SERVICE BULLETIN

APPLICABILITY: 2016MY Impreza, WRX and Crosstrek Models
 2016MY Forester Models

NUMBER: 15-206-16

SUBJECT: USB Device Not Recognized on Fujitsu-Ten (F10)
 7" Display Navigation and Display Audio Units

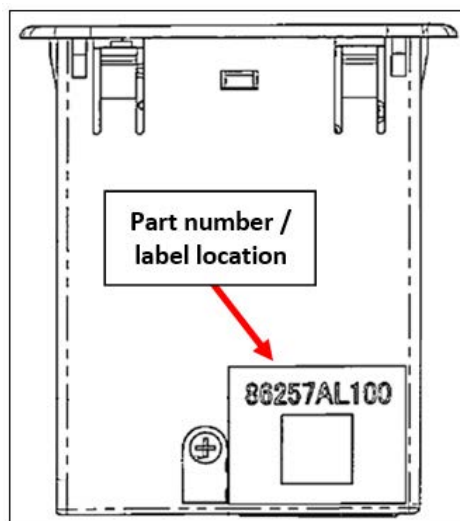
Remove the USB AUX Unit and verify the part number on the underside of the case as shown in the illustration below. If the part number is 86257AL100, replace it with a new **86257AL200** unit along with the applicable exchange audio unit.

REMINDER: The USB AUX Unit and the exchange audio unit must be replaced as a set.
